II. Responses to Comments

A. Introduction

B. Matrix of Comments Received on the Draft EIR

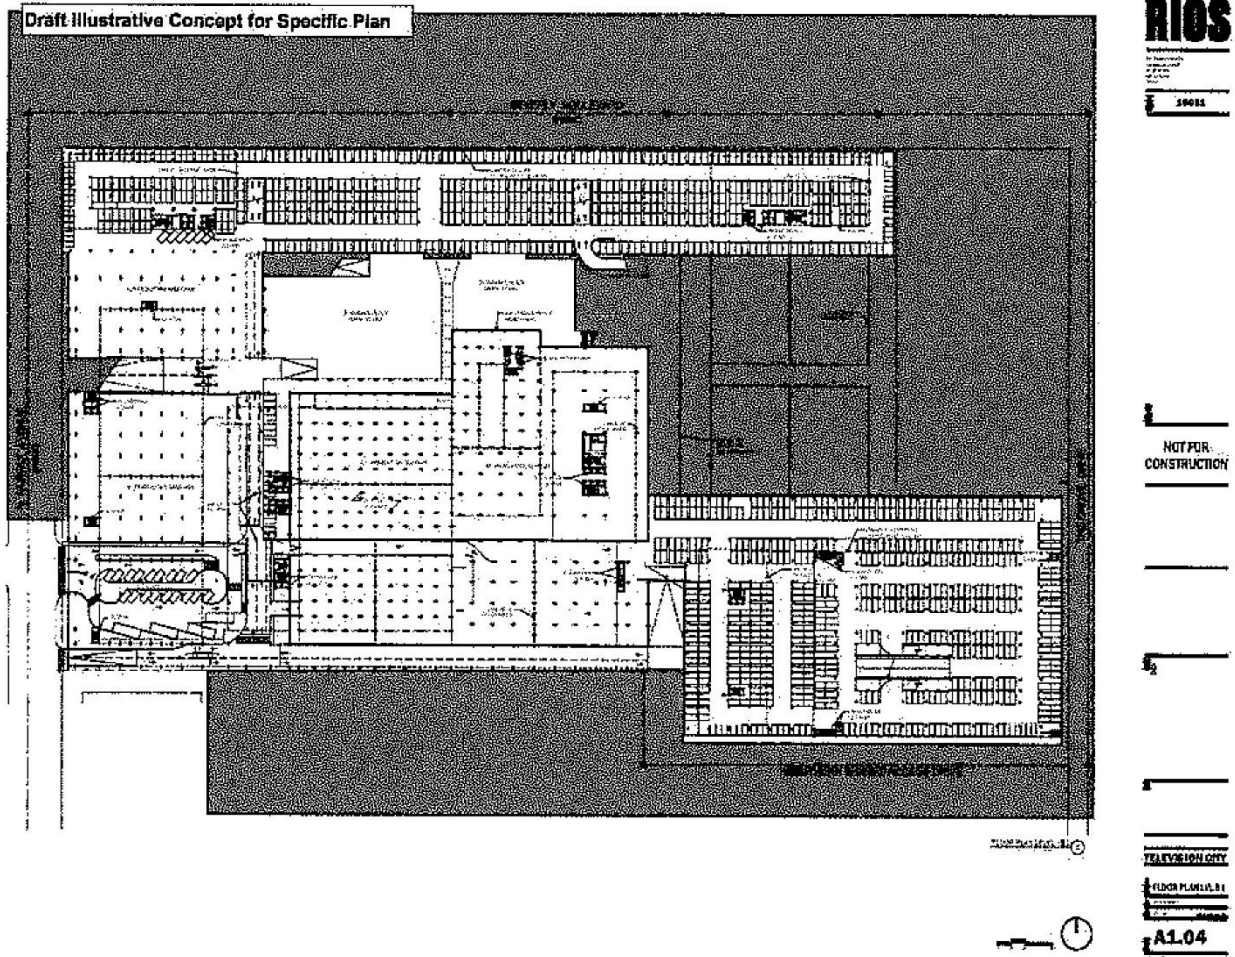
The DEIR footnote redefines permitted “floor area” to exclude the following areas from the Project development square footage and, therefore, from the required analysis throughout the DEIR: “exterior walls; stairways; shafts; light courts; bicycle parking (covered); rooms housing building-operating equipment or machinery; basement and ground floor (covered) storage areas; recycling or waste management equipment or machinery; parking areas with associated driveways and ramps; areas related to the Mobility Hub; outdoor eating areas (covered or uncovered); trellis and shade structures; covered canopies; existing marquees and walkways (covered); outdoor production areas; buildings wholly constructed to house mechanical, plumbing, electrical, or other co-generation and storm water equipment; production trailers; basecamp areas; temporary uses; and sets/façades.” (DEIR, p. II-1.)

The Project’s proposed floor area definition excludes more areas than the LAMC definition of floor area. In significantly expanding the areas to be excluded from the floor area calculation, the DEIR grossly understates the size of the Project and the potential environmental impacts of the Project. Without a clear understanding of how much of these areas, including active production areas and basecamps, are incorporated into the Project, how is the public expected to understand the full scope of the Project? Excluding portions of the actual development from the definition of “floor area” would permit the Project to be much bigger than presented to the public in the DEIR. Thus the Project would have much larger impacts than is studied in the DEIR. The DEIR states, without explanation, that the change in definition would result in an approximately 110,000 square foot reduction in what is included in floor area as compared to the LAMC. How was that calculation made? What is the difference in the LAMC and DEIR definition of floor area?

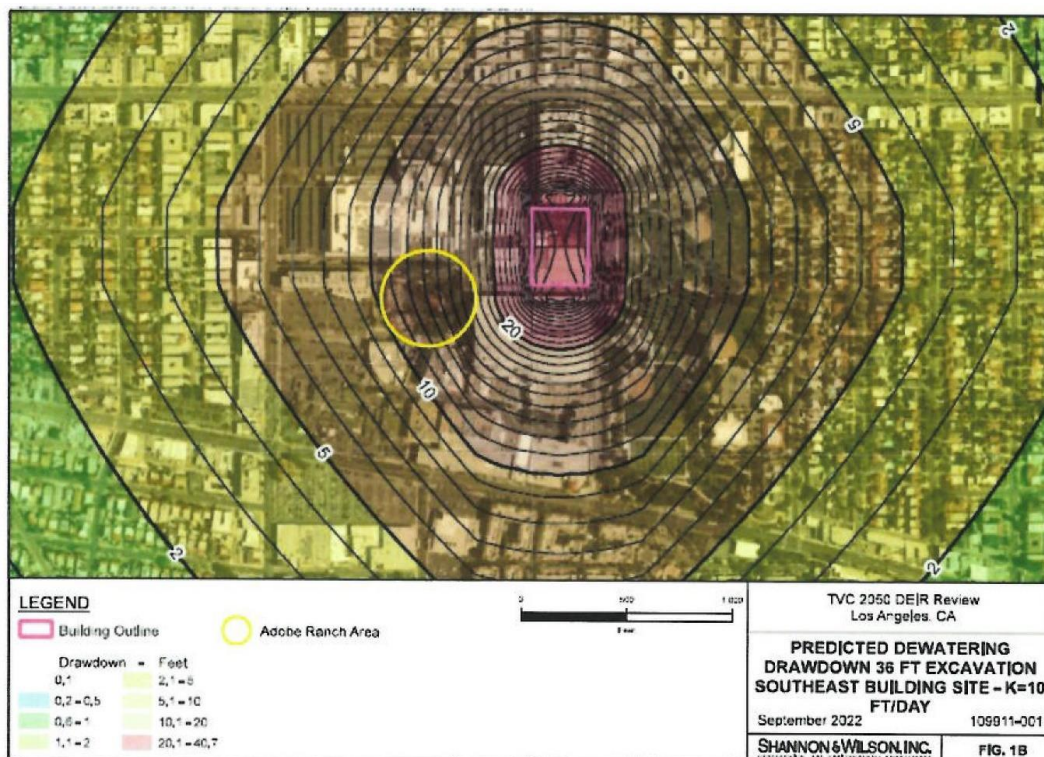
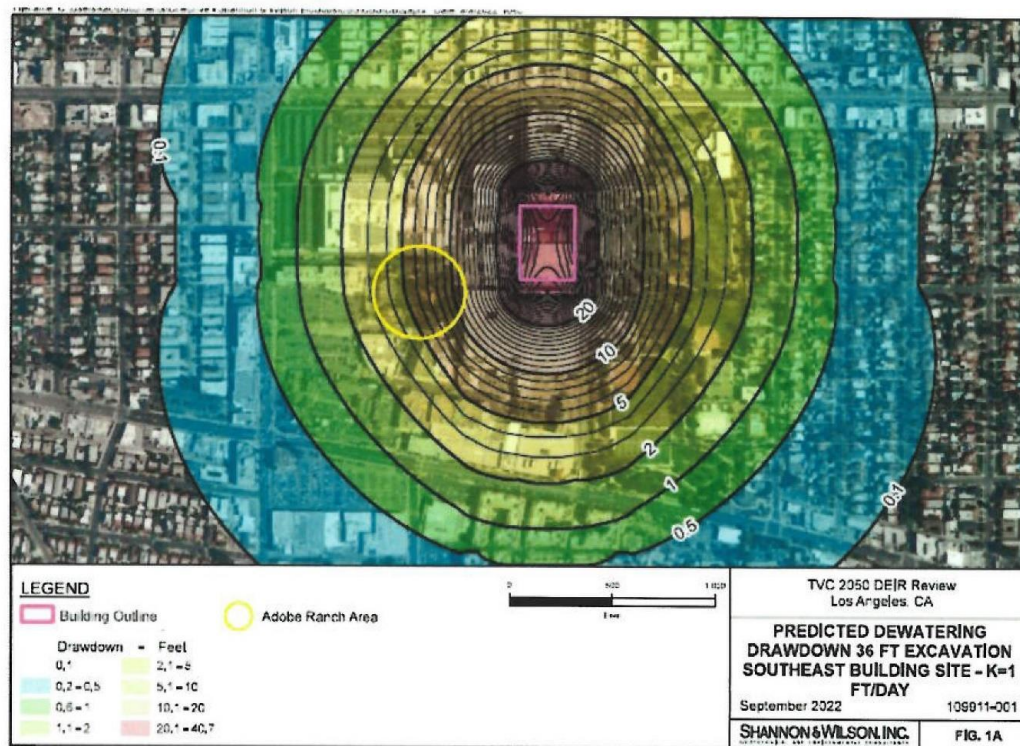
Is there dewatering at the Project Site today? What is the nature and extent of that dewatering? Was that information taken into consideration in developing the Project plans?

There is no dewatering system at the Project Site under existing conditions.

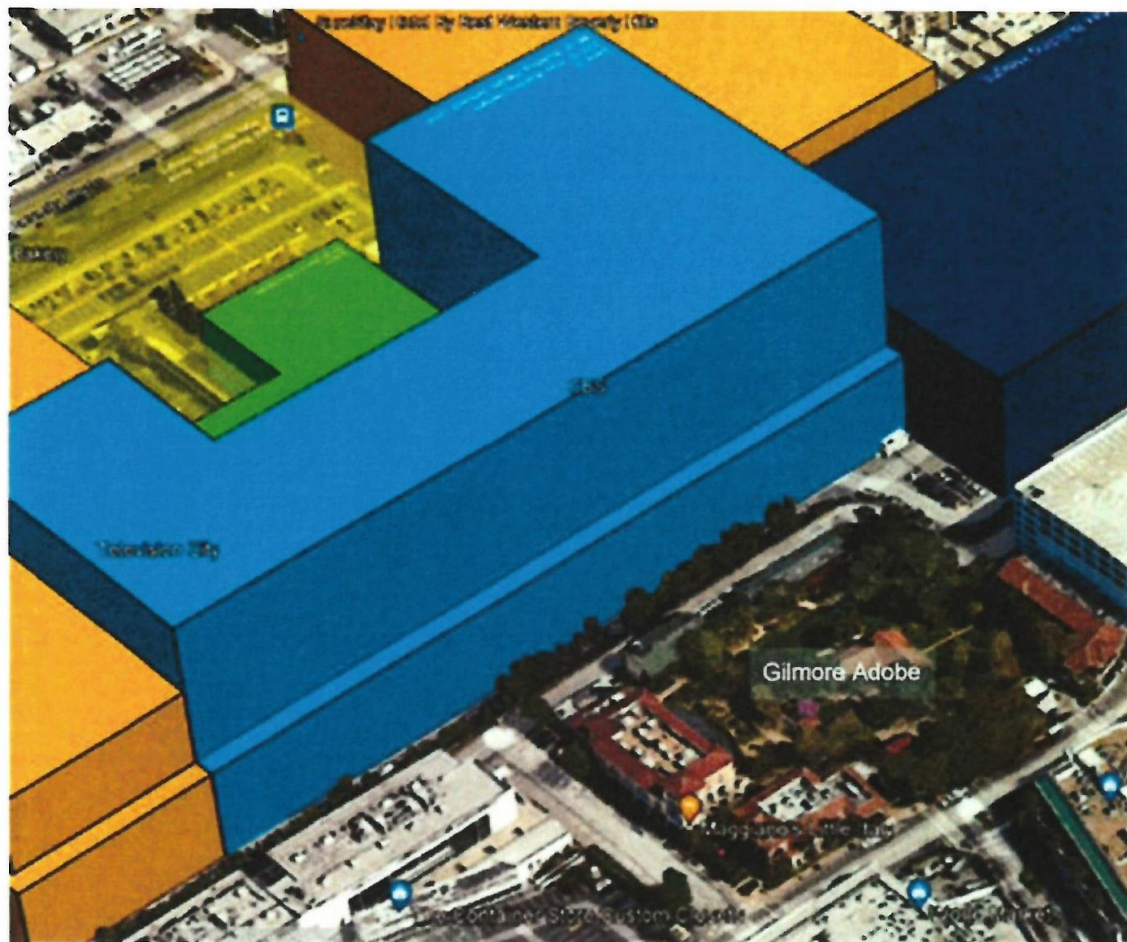
Are the height zones fixed or can they be changed under the Specific Plan? In addition, some height zones have base limits, but are allowed a maximum height for 40% of the area. What was the basis for selecting 40%? The 40% limitation above base height does not appear to be restricted in terms of placement or individual building size. For example, Height Zone C permits building up to 160 feet next to the residential building to the east. Given the land area of Height Zone C, can a 160-foot tall building be built all along the boundary of the Broadcast Center Apartments? That would overwhelm the Broadcast Center Apartments as shown in the 3-D imaging of the Project Height Zones below.

Similarly, can a 225-foot building be built along the southern boundary adjoining the Farmers Market and Gilmore Adobe?

Fig 26: Massing and height zone diagram from DEIR with current aerial superimposed showing Gilmore Adobe and Farmers Market

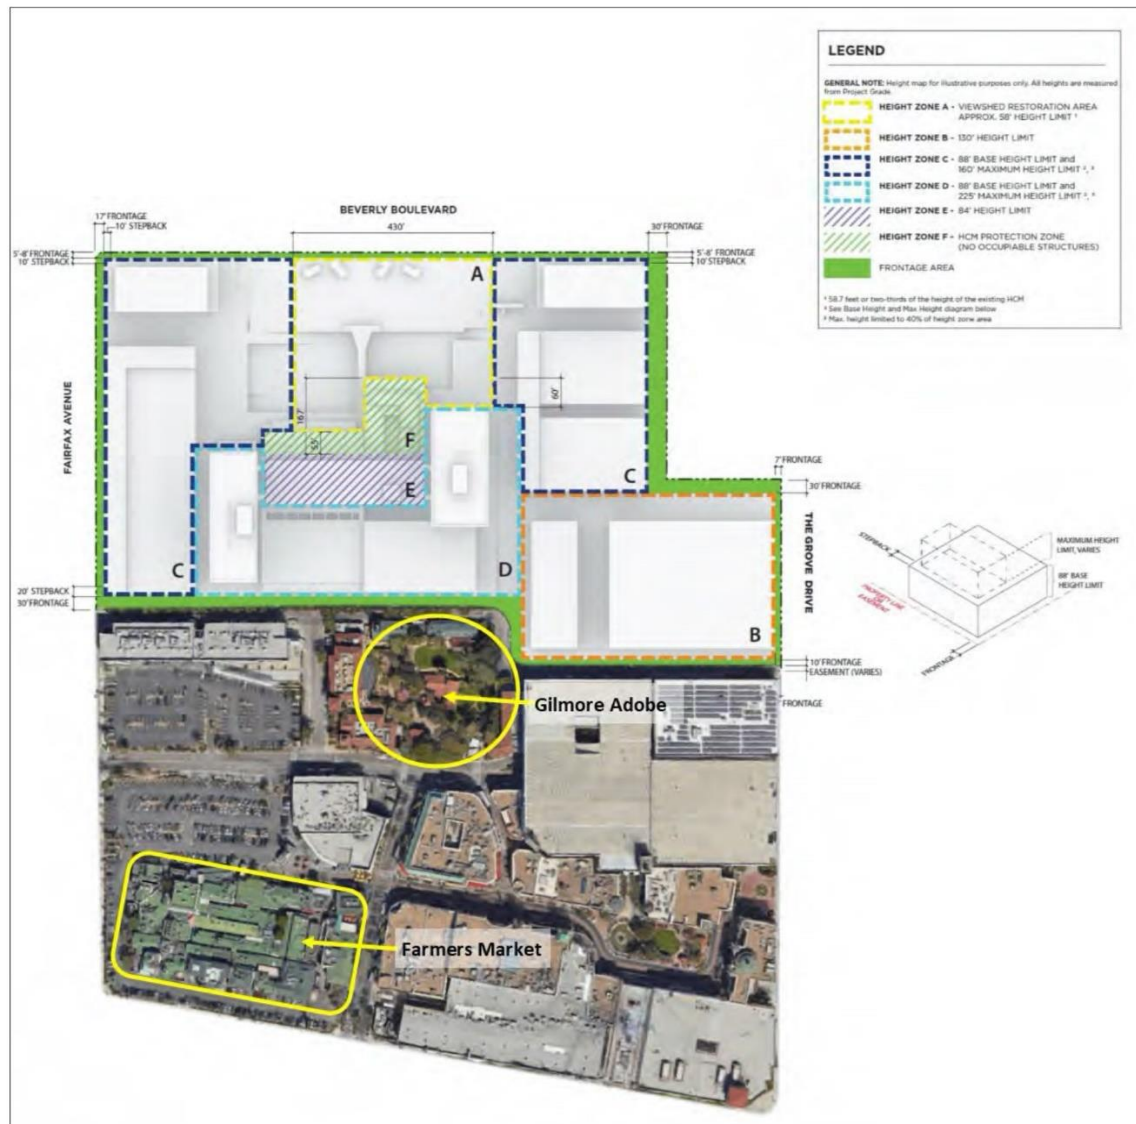
Significant adverse impacts to the Adobe setting would not be avoided by limiting building height to the 88' "base height" (approximately 103' tall as measured in accordance with LAMC requirements) within the same areas characterized by open space and one-story structures, as they would similarly block out access to light and air in the Adobe complex.
